AMENDMENT OF SOLICITATION/MODIFICATION OF CONTRACT				1. CONTRACT ID CODE <div style="text-align: center;">J</div>		PAGE OF PAGES <div style="text-align: center;">1 9</div>

Amendment No. 5

AMENDMENT NO. 5 TO SPECIFICATIONS FOR REVITALIZE BARRACKS USMA PREPARATORY
SCHOOL BUILDINGS 1204 & 1205, FORT MONMOUTH, EATONTOWN, NEW JERSEY

TYPICAL PLAN VIEW FOR ALL FIRST FLOOR TOWER MER ROOMS

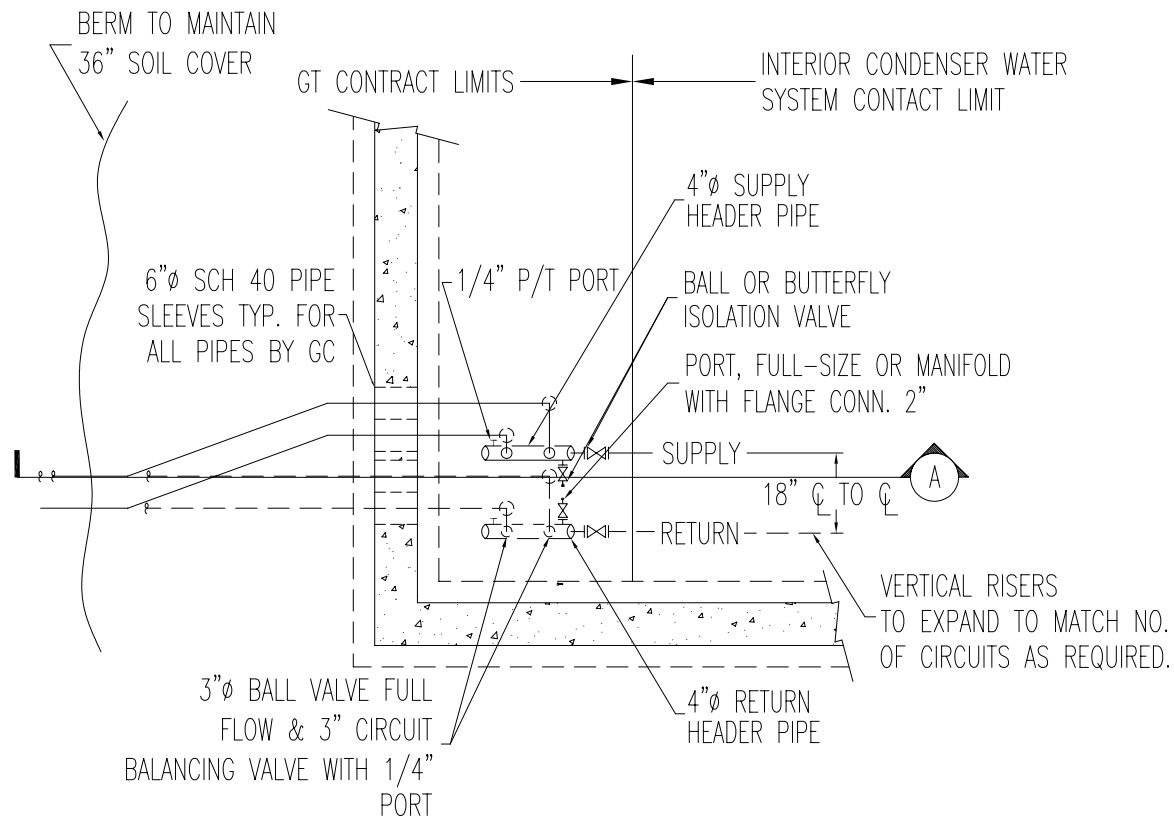
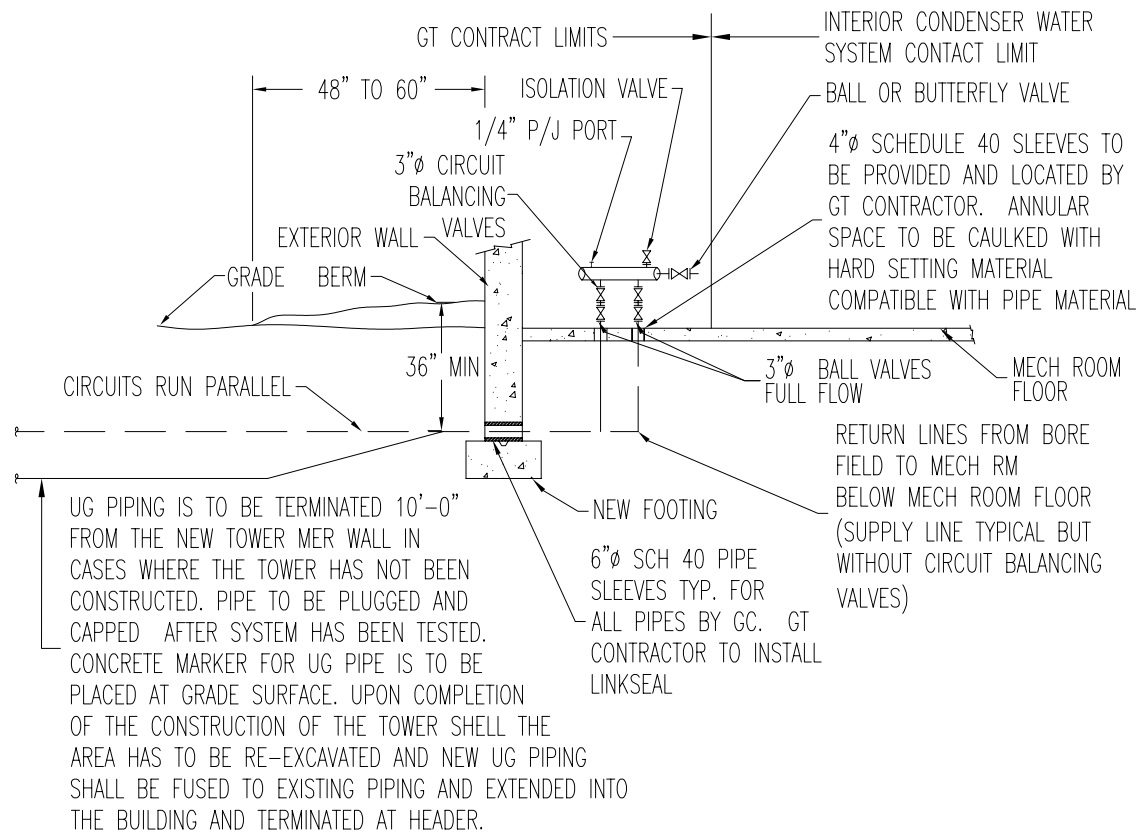
MER 113, BUILDING 1204 - 1 SET-3"Ø S & R CIRCUITS
 MER 114, BUILDING 1204 - 1 SET-3"Ø S & R CIRCUITS
 MER 112, BUILDING 1205 - 1 SET-3"Ø S & R CIRCUITS
 MER 114, BUILDING 1205 - 1 SET-3"Ø S & R CIRCUITS
 MER 123, BUILDING 1205 - 2 SET-3"Ø S & R CIRCUITS
 MER 126, BUILDING 1205 - 2 SET-3"Ø S & R CIRCUITS
 MAIN MER BUILDING 1204 - 5 SET-3"Ø S & R CIRCUITS

G.C. TO CORE DRILL WALLS REQUIRING SCH 40 SLEEVES IN EXISTING STRUCTURES. COORDINATE WITH GT CONTRACTOR FOR INVERT LEVELS. IN NEW TOWERS, SLEEVES TO BE CAST AT INVERT LEVELS PROVIDED IN GT SUBMITTALS (TYPICALLY 48" FROM GRADE TO C OF SLEEVE.) IN ALL CASES UPON COMPLETION OF GT PIPING GC TO BACK FILL AREA WITH BANK RUN GRAVEL, COMPACT USING MECHANICAL VIBRATOR, PROVIDE 6" O.C. x 6" O.C. OPEN MESH WITHIN CONCRETE SLAB. AREA TO BE PATCHED WITH 3500PSI CONCRETE INSTALLED LEVEL AND SMOOTH COORDINATE ELEVATION OF PIPES GOING THRU WALLS WITH GT CONTRACTOR.

SKETCHES: TYPE II CANOPY

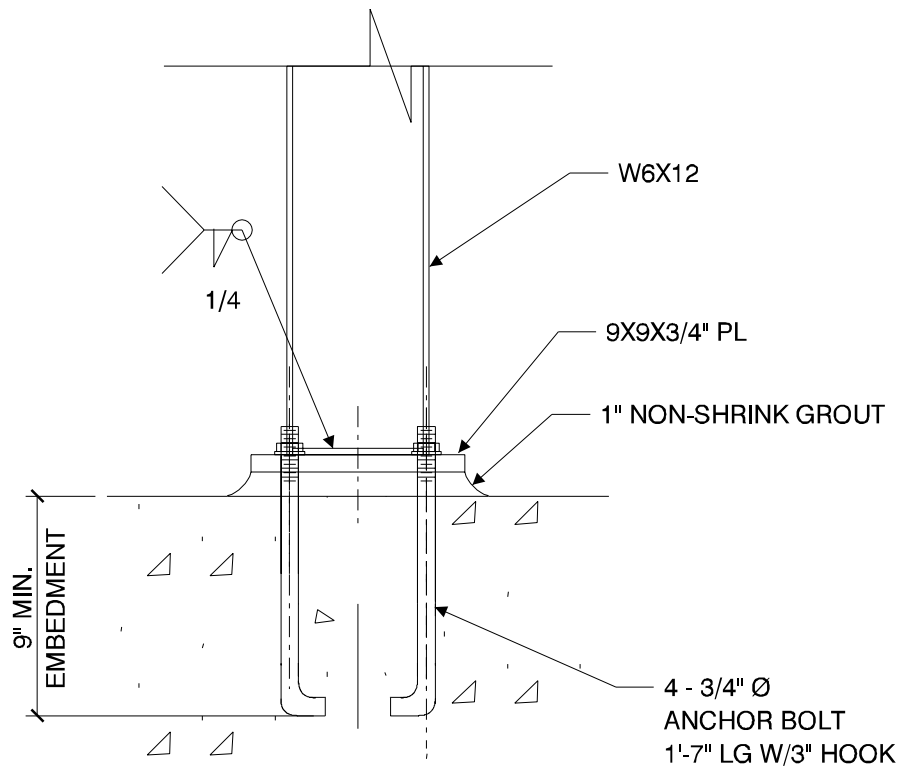
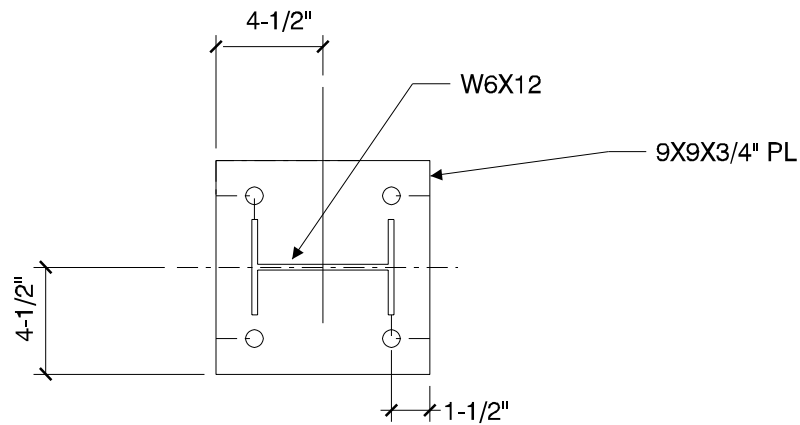
- Type II Canopy
 - Canopy Detail A: Typ. Base Plate Connection to New Conc. Foundation or New CMU Wall
 - Canopy Detail B: Typ. Moment Connection at Ridge

SKETCH: CANOPY DETAIL B
TYP. MOMENT CONNECTION AT RIDGE

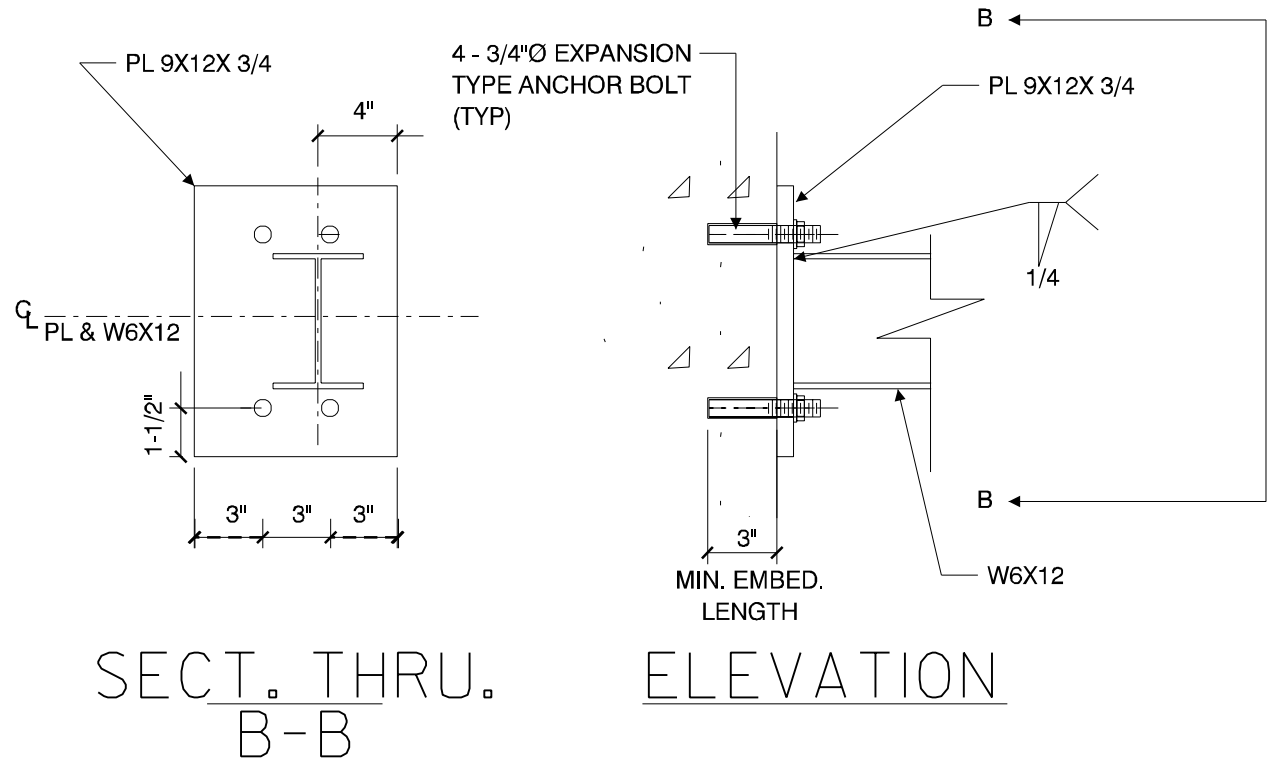
(1) UNLESS OTHERWISE APPROVED BY THE CONTRACTING OFFICER, EXPANSION TYPE ANCHOR BOLTS SHALL BE USED AND SHALL BE DESIGNED TO SUPPORT A MINIMUM TENSILE LOAD OF 1750 LBS. AND SHEAR LOAD OF 2875 LBS.

SKETCHES: CANOPY DETAIL C
TYP. BASE PLATE TO EXISTING
CONC. COLUMN CONNECTION

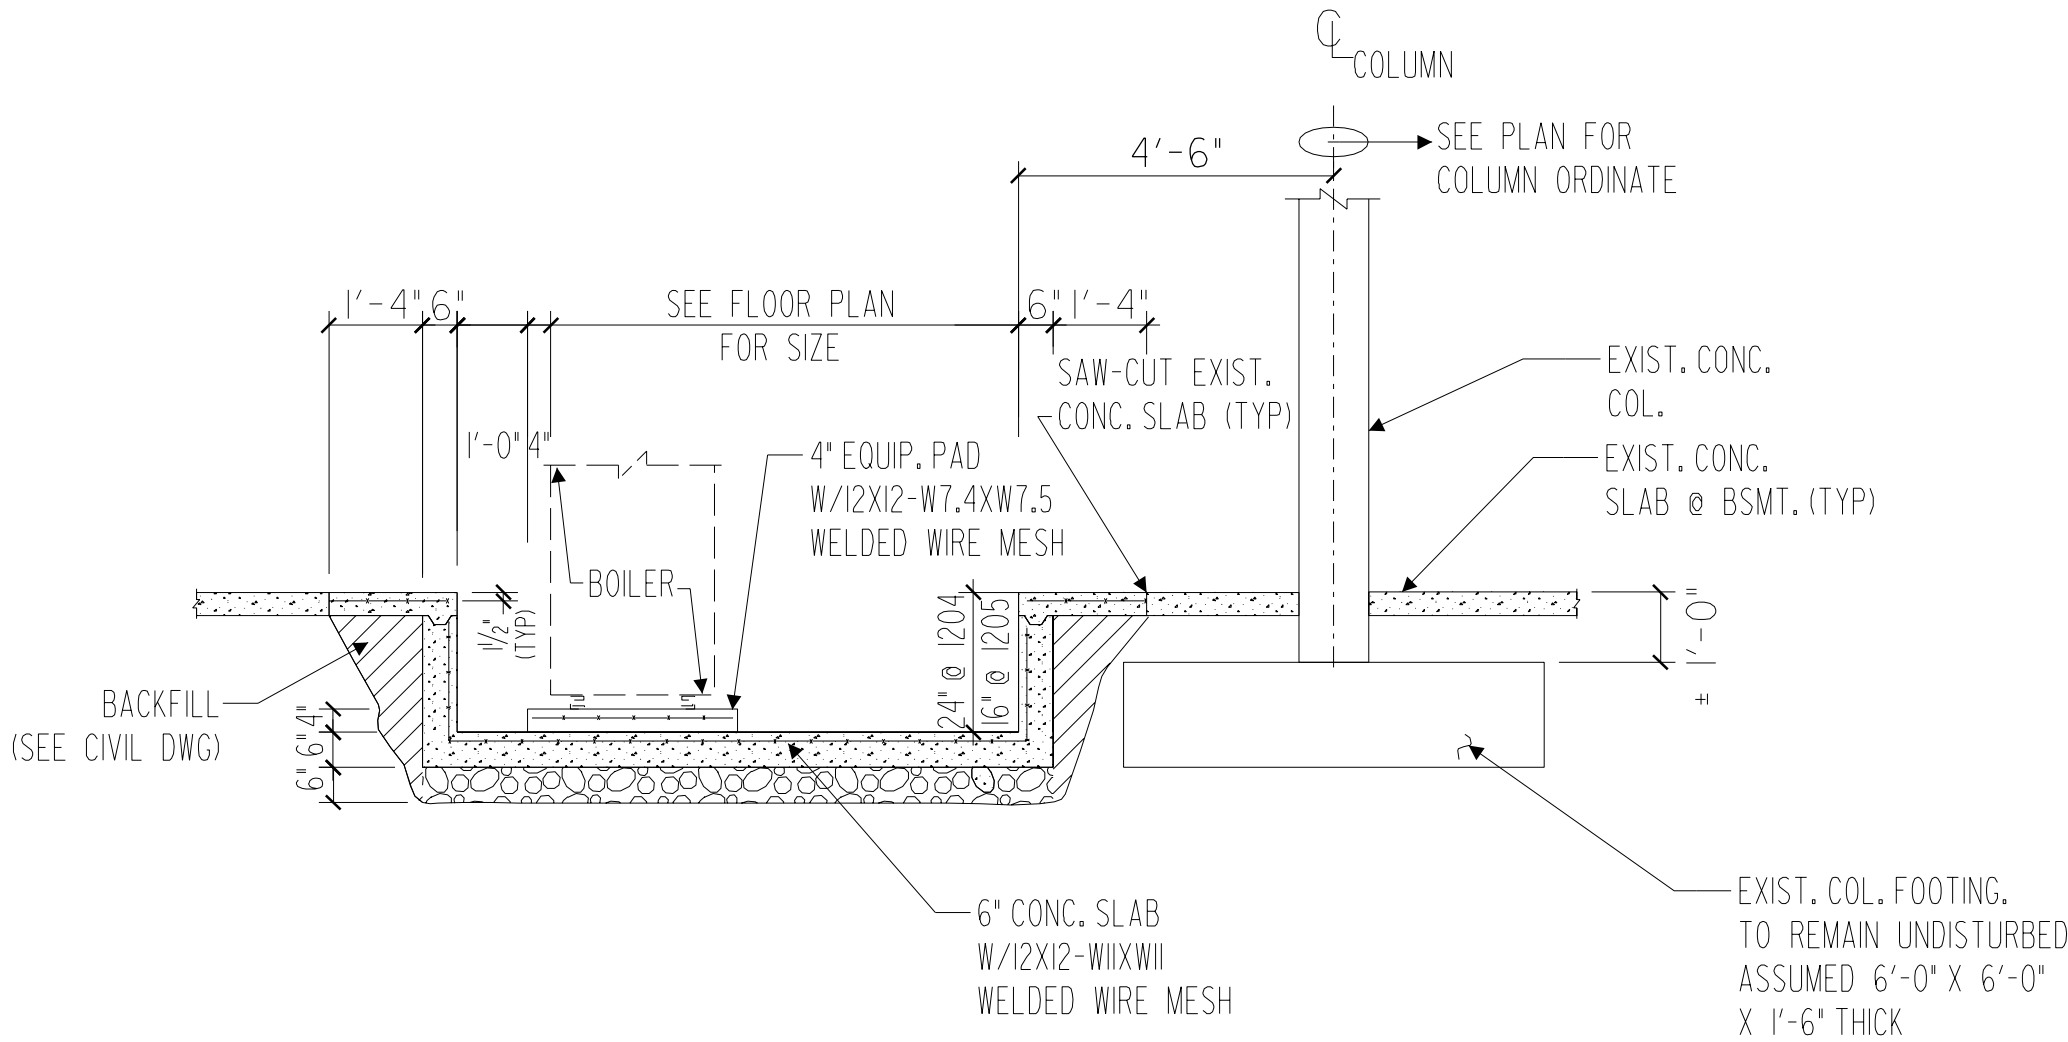
- Canopy Detail C: Typ. Base Plate to Existing Conc. Column Connection
 - Concrete Reinforcement: Section Thru Mechanical Pit
 - Concrete Reinforcement: Section Thru Elevator

SKETCH: CONCRETE REINFORCEMENT
SECTION THRU MECHANICAL PIT

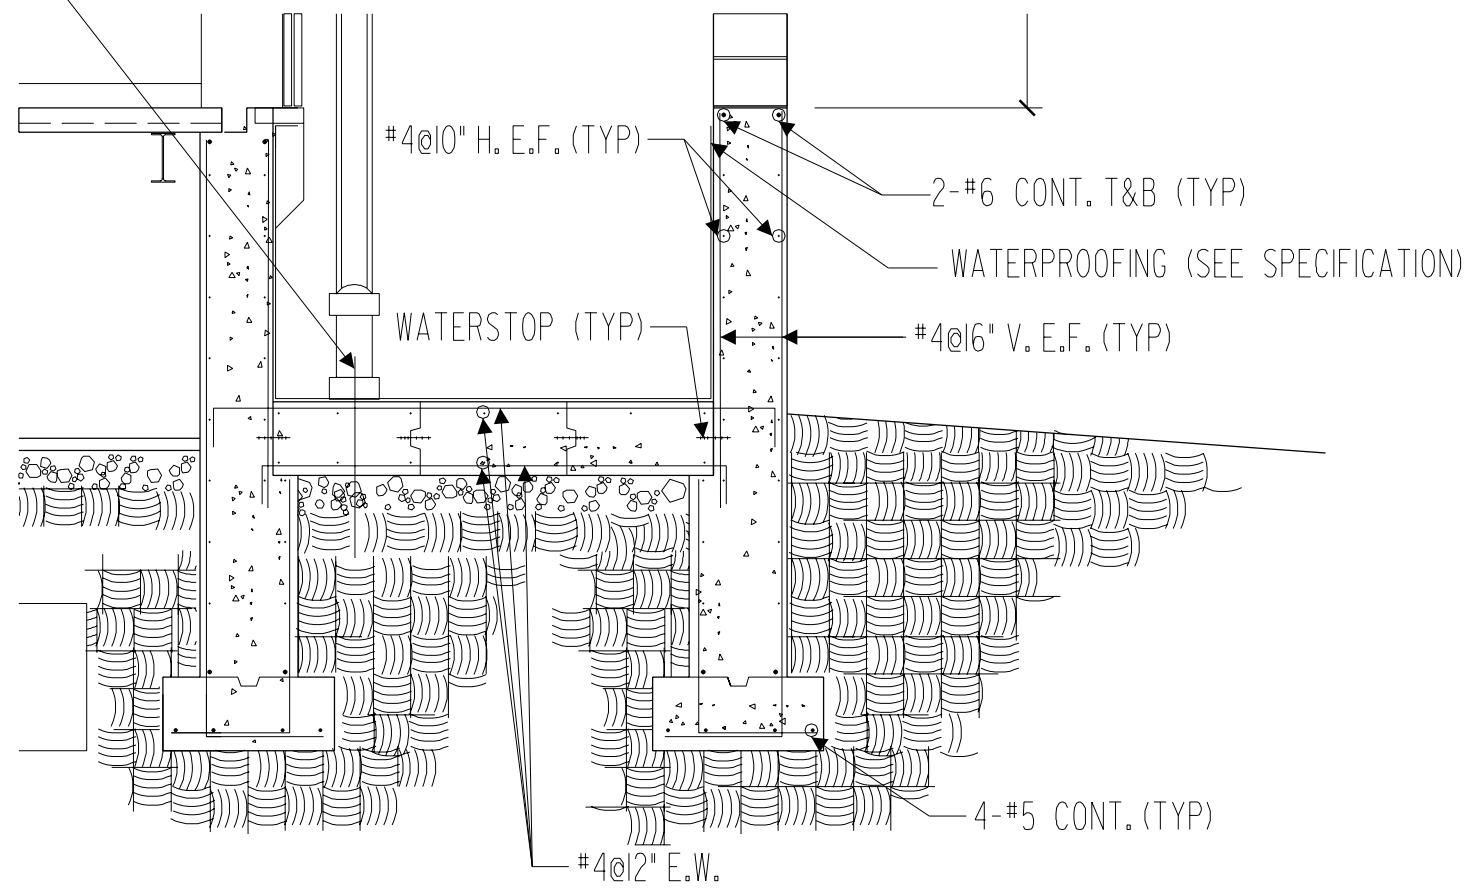
BLOCKOUT FOR CYLINDER
FILL W/CON. AFTER
CYLINDER INSTALLATION.
COORDINATE SIZE AND
LOCATION W/ELEVATOR
MANUFACTURER

SKETCHES: HANDICAPPED RAMP (TYP)

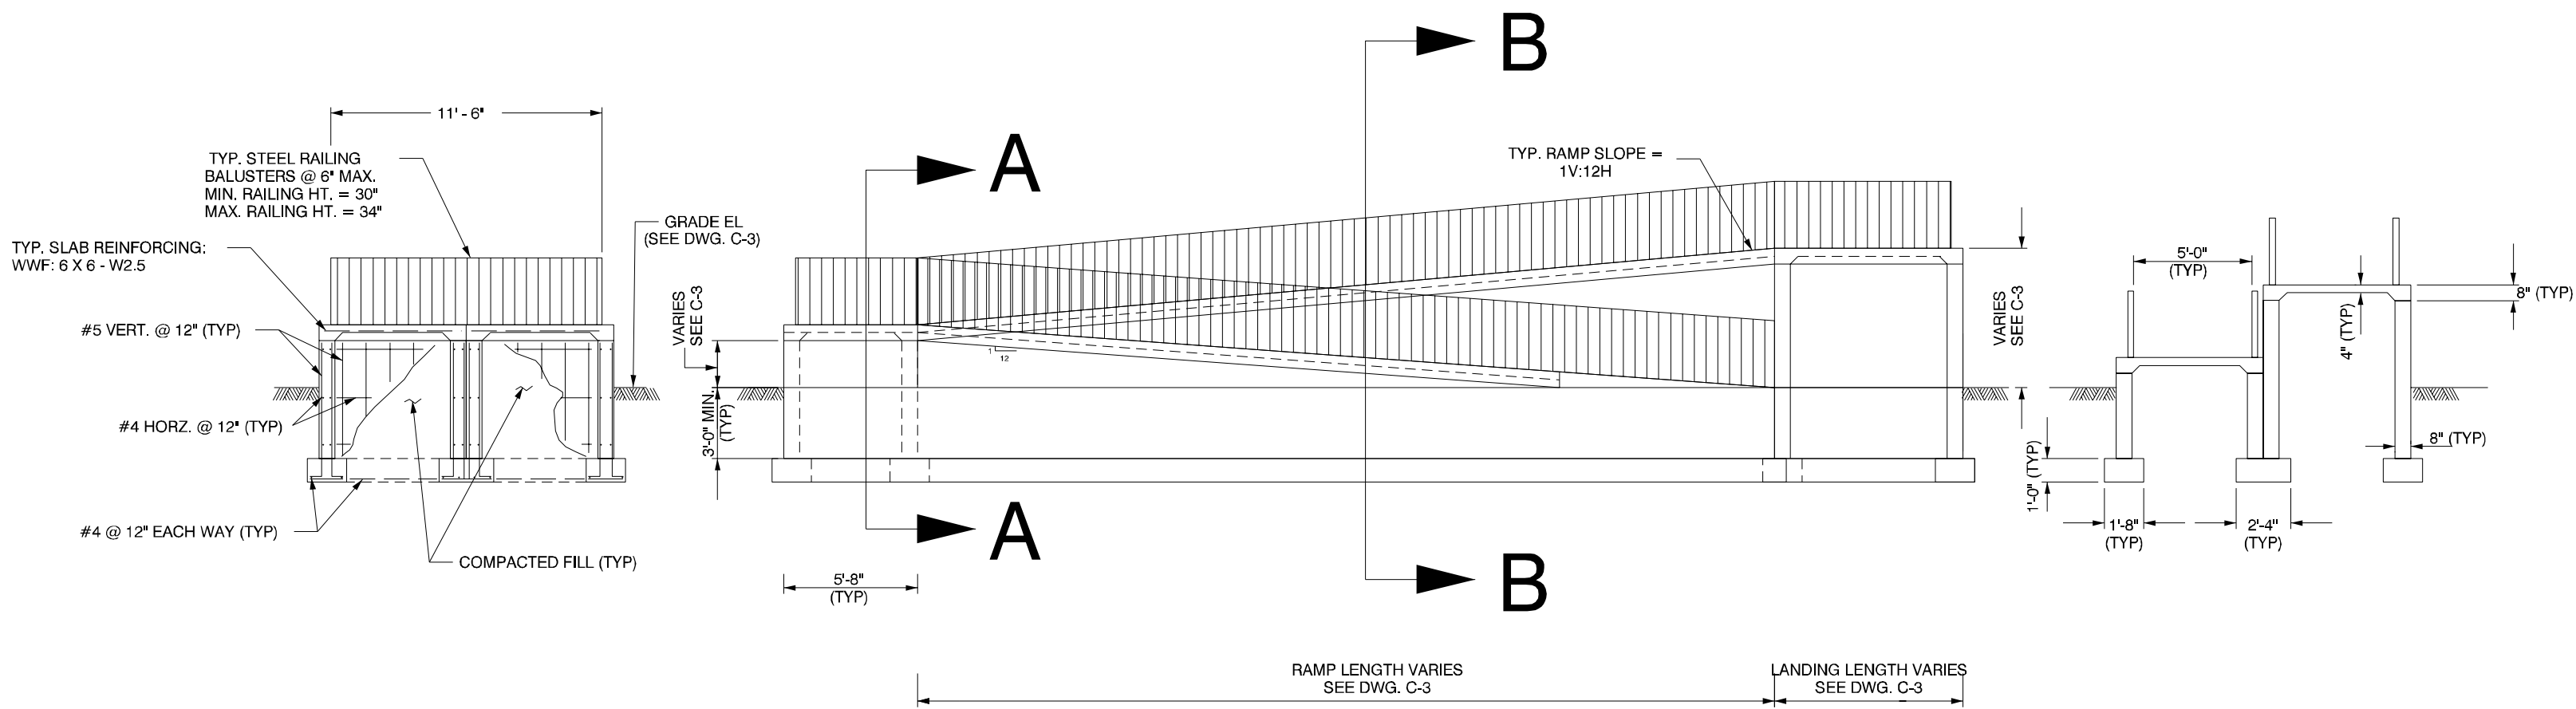
- a. Internal stair section - Will be provided.
External stair section - See Drawing A-036.
- b. Handicapped Ramp - See this Amendment.
- c. Tower Roof - See Drawing A-037.
- d. New Canopies - See this Amendment.
- e. Connecting Link - See Drawings S-02 and A-039.
- f. Slab on Grade see Drawing A-036.
- g. Floor Slab - see Drawing A-036.

- NOTES:
1. RAMP GRADES SHOWN ON DWG. C-3.
 2. ALL RAILINGS SHALL BE INSTALLED AS PER MANUFACTURER'S APPROVED METHOD.
 3. PLAN VIEW SHOWN ON DWG. A-039.
 4. CONTRACTION JOINTS @ 4'-0" FOR ALL SLABS.
